**ONCOR Nacogdoches Southeast Switch –  
Redland Switch-Lufkin Switch 345-kV Loop  
Project – ERCOT Independent Review**

**Regional Planning Group**  
April 15, 2021

# Option 2

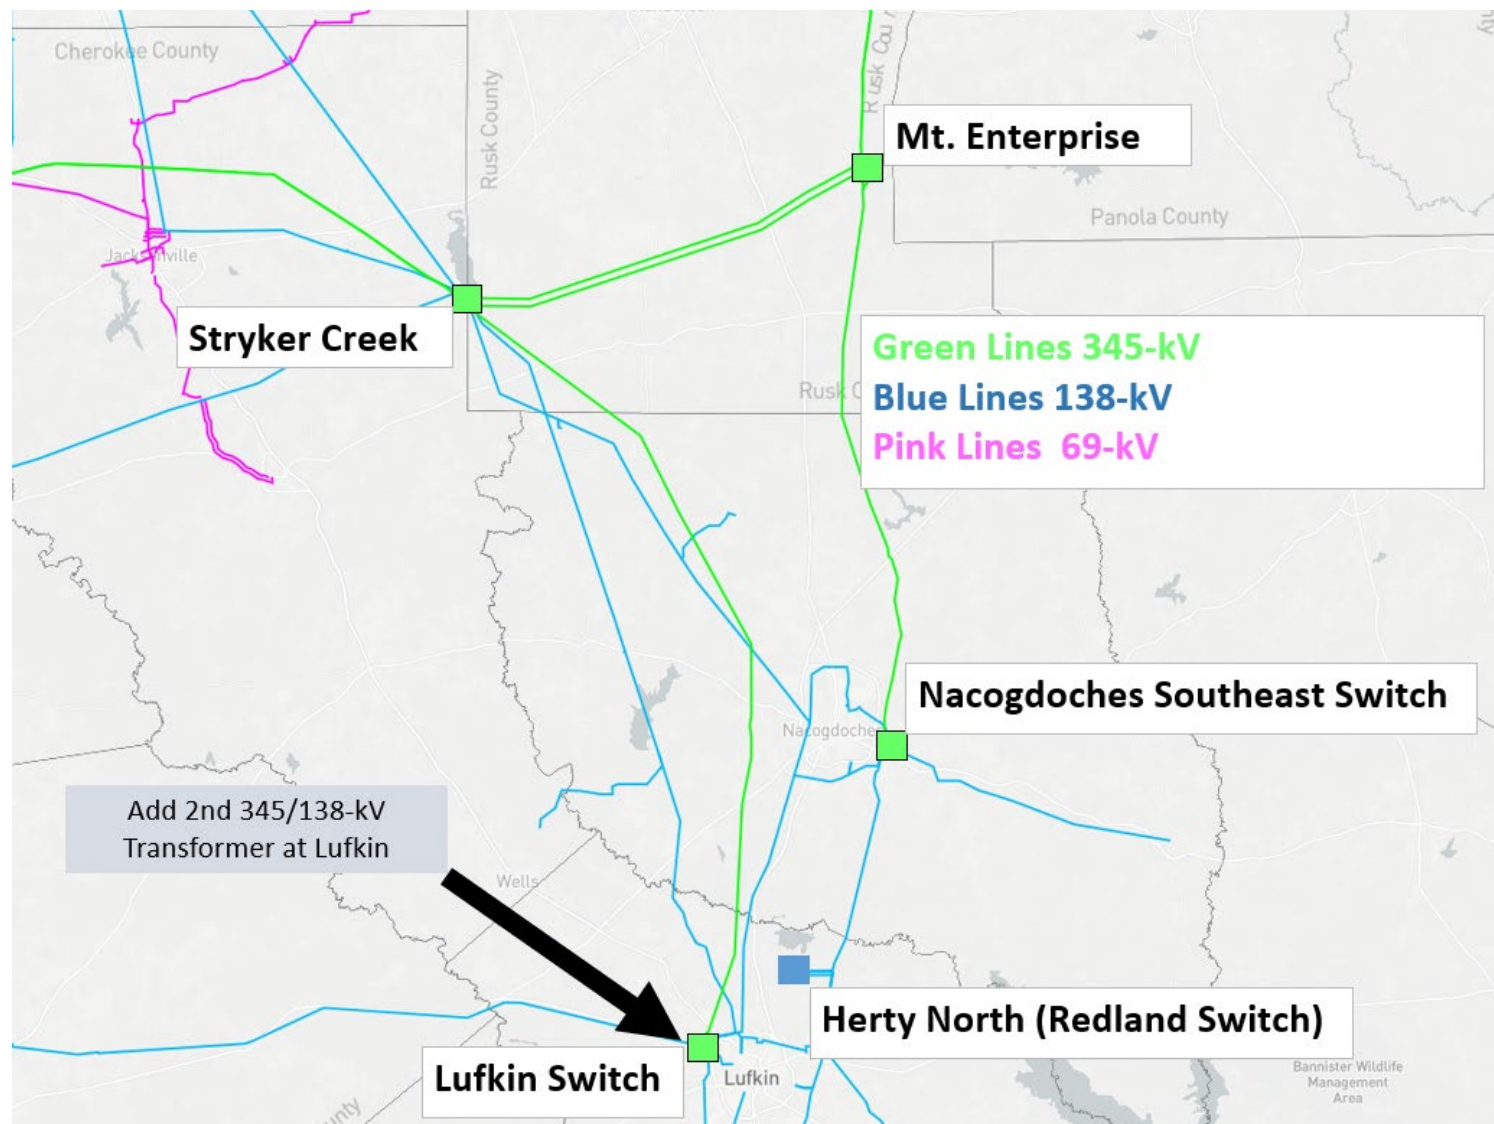
Based on these results Option 2 was eliminated from short-listed Options

# Option 3

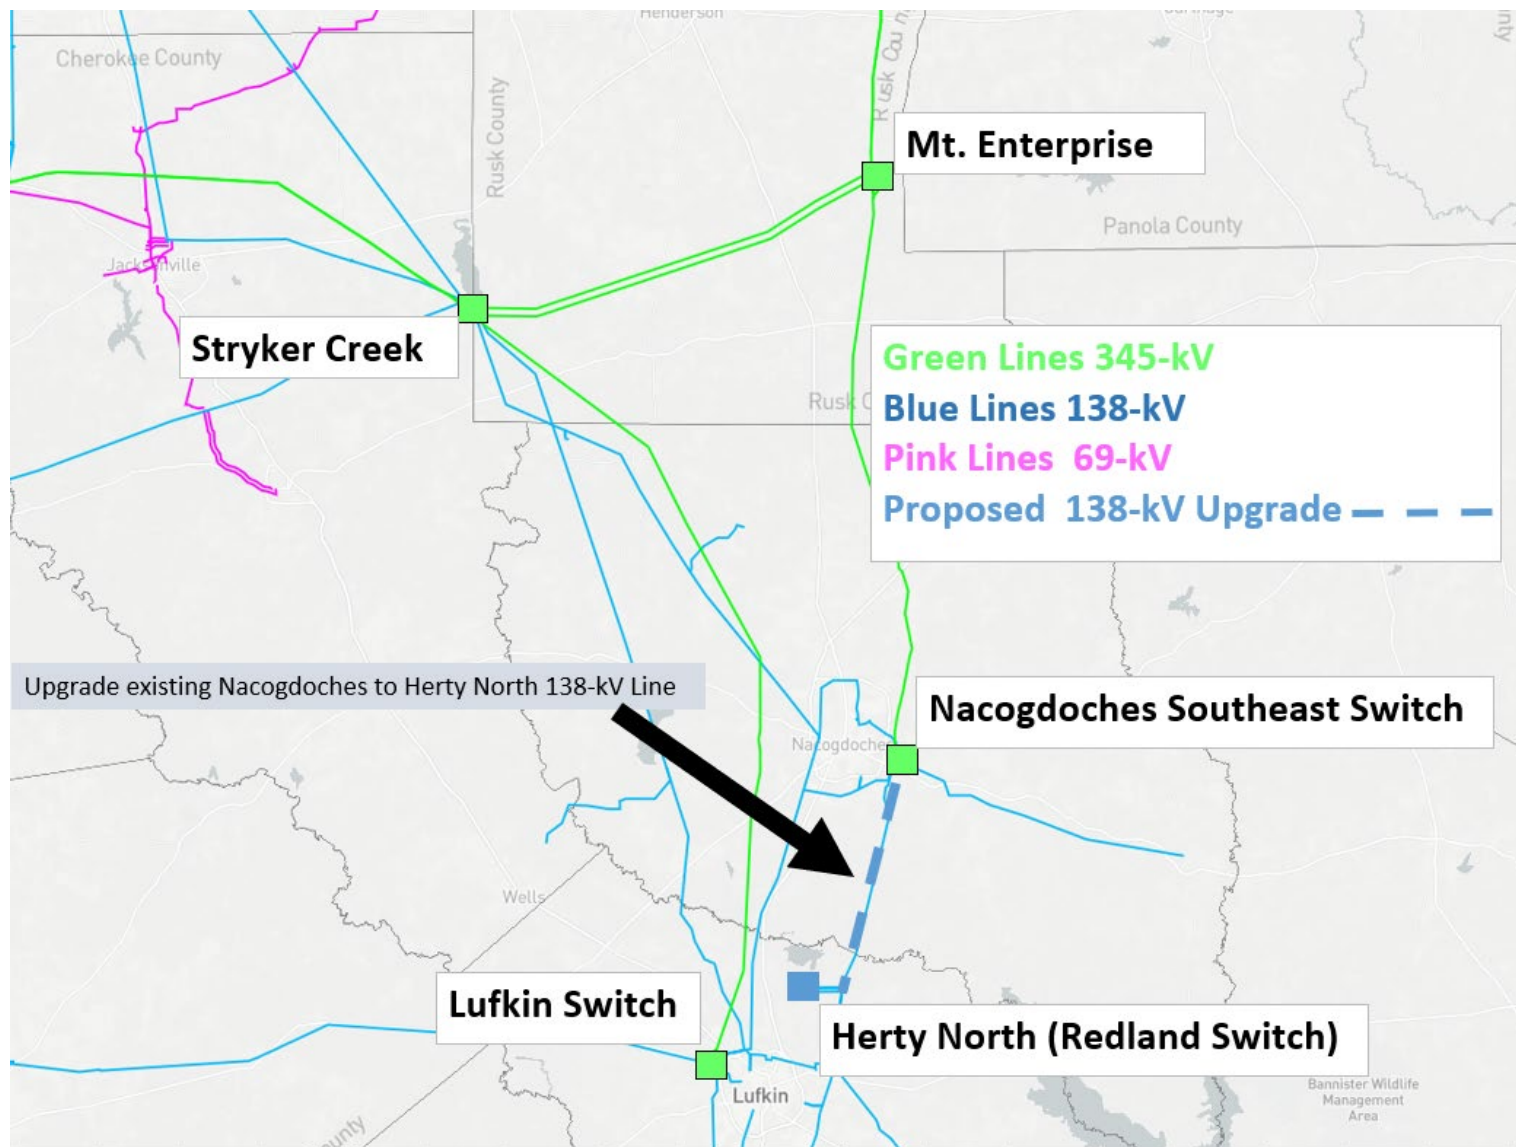
Based on these results Option 3 was eliminated from short-listed Options

# Short-listed Options Comparison

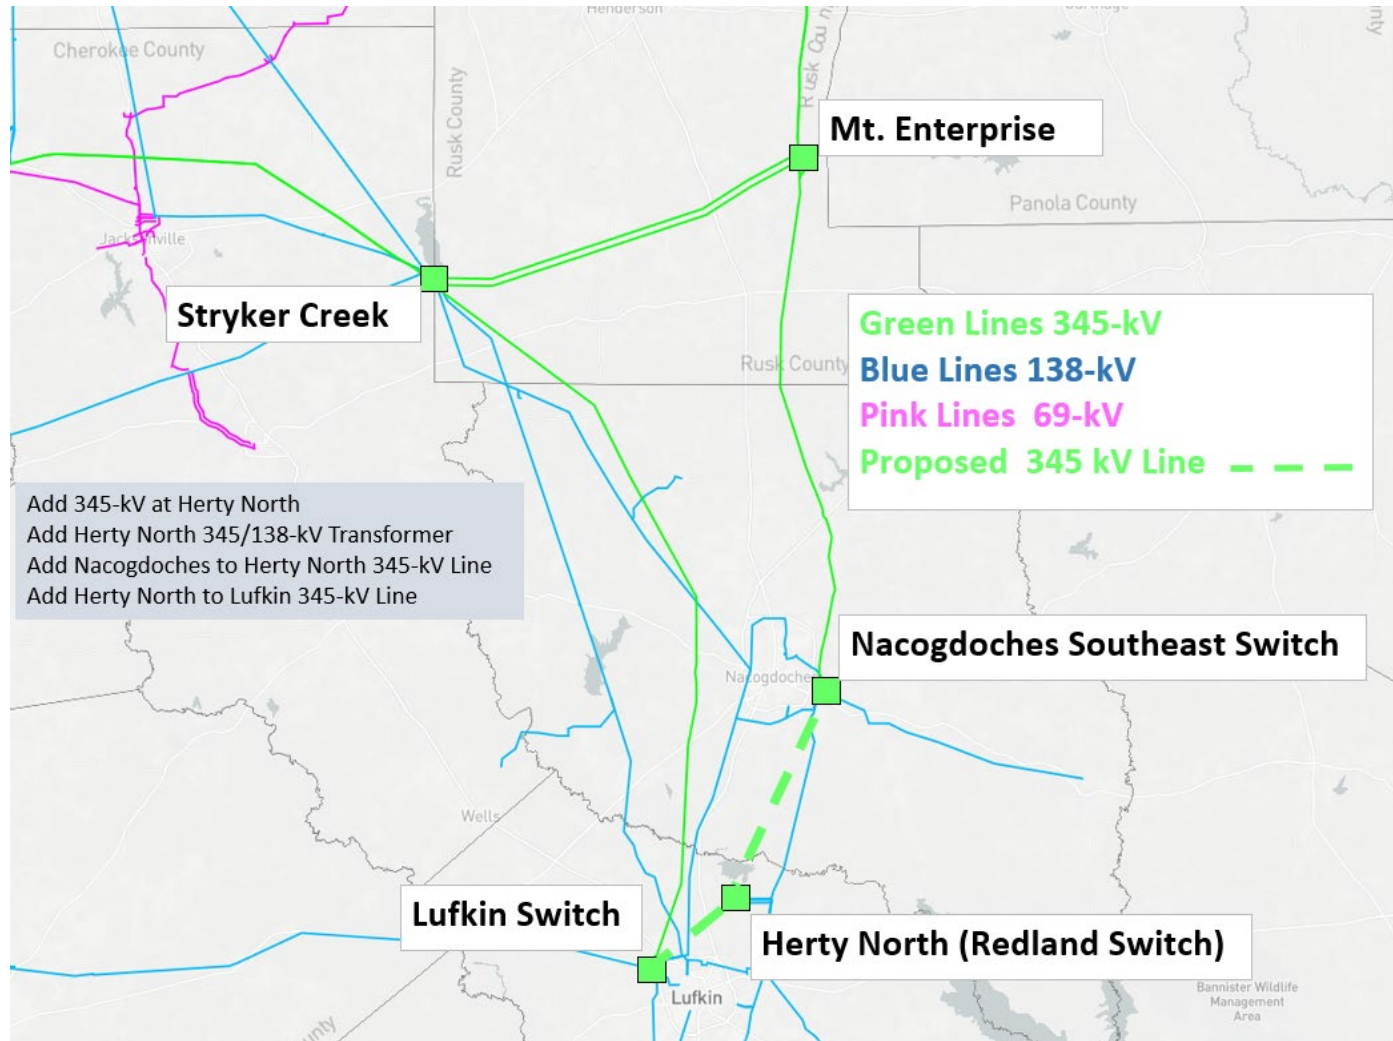
Although Option 1 is slightly more expensive than Option 4, Option 1 provides the following benefits over Option 4:

- Better long-term load serving margin by producing lower line loadings
- Better operational flexibility during the maintenance of the 345-kV equipment in the area since it provides two sources of 345-kV to Lufkin, Nacogdoches and Redland
- Better voltage support for the entire Southeast Area by creating a 345-kV loop and an additional power injection point at Redland
- Transformer redundancy by installing a new 345/138-kV transformer at the Redland
- Relatively shorter duration of construction outages

ERCOT prefers Option 1
